**AERONAUTICAL CHARTING FORUM**  
**Instrument Procedures Group**  
**October 23, 2012**

**FAA Control # 12-02-306**

**Subject:** Class B Airspace Containment of Instrument Approach Procedures

# ILS or LOC RWY 9 MIAMI INTL (MIA)

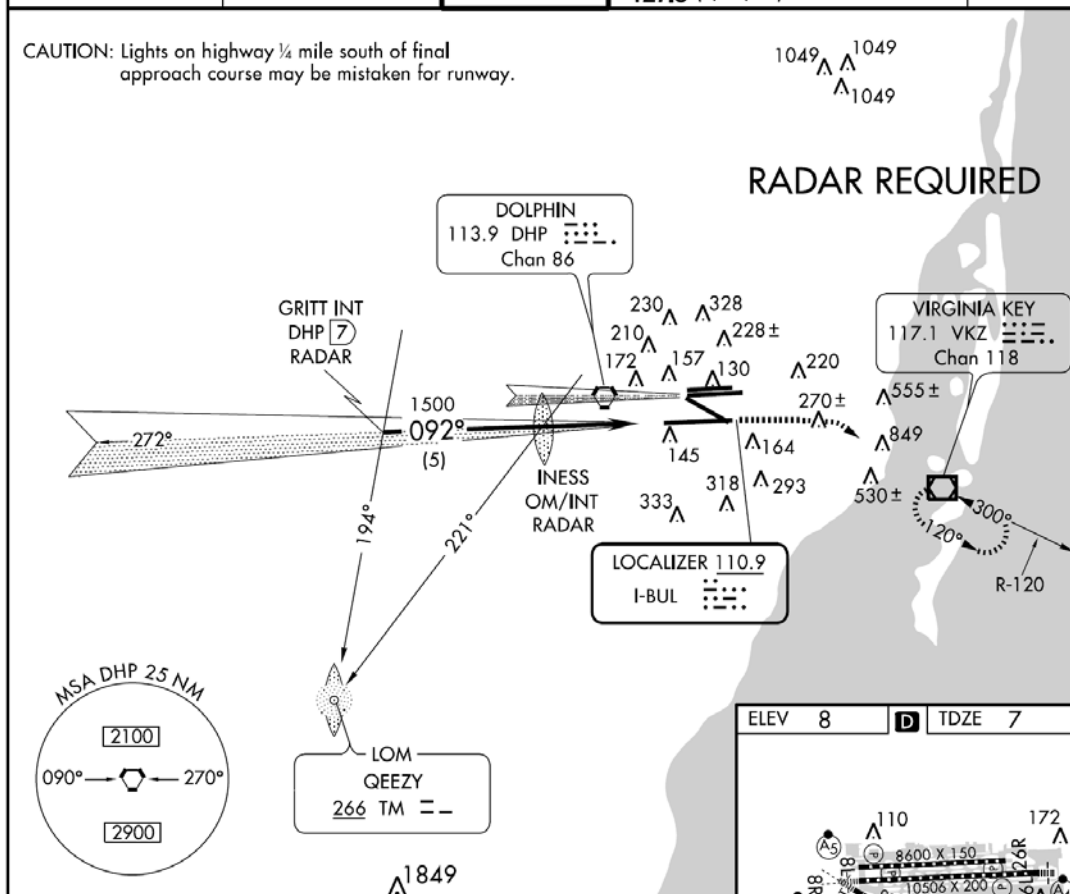
**Background/Discussion:** It was brought to the attention of the Allied Pilots Association (APA) AA Safety Action Program (ASAP) Team that there may be a systemic problem with ensuring Class B Airspace containment for instrument flight procedures. For example, the Miami, Intl. Airport (KMIA) ILS RWY 9 glideslope descends out of Class B airspace for approximately 1 NM before reentering. If glideslope is intercepted at GRITT, aircraft will be below the 3000 foot floor of Class B airspace for approximately one mile before it will re-enter the Class B at the point where the Class B floor becomes 1500 feet. The same situation occurs on the RNAV (GPS) RWY 9 when the pilot departs 3000 at HODLE, which is .5 NM farther away from the 1500 foot Class B floor sector. This will cause a violation of 14 CFR Part 91.131(a)(2) (operation of a turbine aircraft below Class B airspace floor while operating to the primary Class B airport) as well as create a potential midair conflict with aircraft operating under the Class B airspace. It has also been reported that some controllers delay clearances for approach (presumably more for visual approaches) for consideration of the Class B airspace floor, thus causing aircrews to be rushed in descent and aircraft configuration for landing, which results in an unstable approach. We also believe there were similar problems at Phoenix and Las Vegas that have been corrected.

**Initial Discussion - Meeting 12-02:** New issue introduced by Lev Prichard on behalf of the Allied Pilots Association, APA. Lev expressed concern that the ILS RWY 9 approach at Miami Int'l (KMIA) allows pilots, when intercepting and flying the glide slope (GS), to descend below the floor of Class B airspace. This causes the pilot to violate 14 CFR Part 91.131(a)(2). Kevin Allen, US Airways, noted that this problem is not isolated to KMIA, but also occurred at Phoenix and Las Vegas. Kevin added that it is concerning that when this type discrepancy is noted and reported, it takes years to amend the Class B airspace to contain the procedures. Gary McMullin, SWA, agreed that this is a nationwide issue as there are more and more problems associated with Class B containment of instrument procedures. He noted that the local ATC facility is the key link in ensuring containment via procedure design or Class B modification. Paul Eure, AJE-31, stated that the FAA Airspace, Regulations, and ATC Procedures Group, AJV-11 is undergoing a complete review of all Class B airspace. Thus far 6 have been modified and 12 others are under review. Bob Lamond, NBAA, stated that airspace re-design is a complicated process and added that he did not support two groups working the same issue. Bob stated that since Class B airspace is a continuing safety issue on the ATPAC agenda, he believes the issue should be expanded within ATPAC to address the APA concerns. Steve Serur, ALPA, noted that the Class B airspace initiative had begun as a corrective action after a 1986 Aero Mexico aircraft accident in Cerritos, California and he believes the issue should be worked through the ACF-IPG as it violates established rules. Bill Hammett, AFS-420 (ISI), agreed with the NBAA representative in that two entities should not be working the same issue and this particular issue should be worked through ATPAC. Airspace within the NAS is under the purview of the ATO, specifically, the Airspace, Regulations, and ATC procedures Group, AJV-11. Currently the Manager of AJV-11 is Gary Norek, who is also the current Acting Executive Director of ATPAC. Having the same person in charge of these two organizations should provide an added benefit in getting expeditious action on the issue. As noted, ATPAC is currently sponsoring a review of all Class B airspace areas. The APA issue should be able to be incorporated in this study or accepted as a separate ATPAC Area of Concern. ATPAC has an assigned membership of 17 organizations, including APA and American Airlines. Bill stated that while he is pleased that APA and others acknowledge the ACF as an organization that achieves results, he also believes that ATPAC can be more effective on this and other issues, especially if encouraged by their membership. Lastly, Bill stated that the current policy in FAA Order JO 7400.2 mandates that the Class B vertical limit "....must

This policy could not be more clear; however, the applicable offices may need to be reminded that on ILS approaches, there are two final approach fixes (FAFs), one for the ILS and one for the LOC. These points may or may not be co-located as in the case of KMIA. The glide slope intercept point is approximately 5 NM from and 1,500 higher than the designated LOC FAF. This should have been noted by the Service Area Flight Procedures Team and/or the ATC facility during the coordination phase of the approach and fixed prior to publication (either by moving the glide slope intercept point or amending the Class B vertical limit). In short, if the current policy was followed, the situation would not exist. Rick Dunham, AFS-420, asked what should be done in the interim. Gary McMullin responded that a note could be placed on the charts, something to the effect "procedure may exit Class B Airspace." Brad Rush, AJV-3B, spoke against this recommendation, stating that if a chart note were accepted as mitigation, AT would never enforce compliance. No other suggestions were offered. Tom Schneider, AFS-420, as ACF-IPG Chair agreed the issue should be worked through ATPAC and the issue will be closed from further consideration by the ACF-IPG. Tom stated that he will forward a copy of the APA issue and the record of the ACF-IPG discussion to the ATPAC Executive Director and recommended APA (with support of other interested ATPAC members) present the issue as an Area of Concern at the next ATPAC meeting. **ITEM CLOSED.**

**Recommendations:** Recommend that special attention be given to ensure that the glideslope intercept point is included as a final approach fix when considering Class B vertical and lateral limits. When such discrepancies are discovered, corrective Class B airspace action should be expedited on an immediate final rule basis. Notice is unnecessary because such an amendment would be a technical amendment to bring the Class B area into compliance with the intent of the previous Class B major rulemaking.

**Editor's Post Meeting Note:** *The following quote from Order JO 7400.2 has been added to Change 3 to FAA Order 8260.19 under paragraph 5-8c as an additional reminder: "The Class B vertical limit must encompass, as a minimum, all final approach fixes and minimum altitudes at the final approach fix to include the glideslope intercept point for ILS approach procedures."*
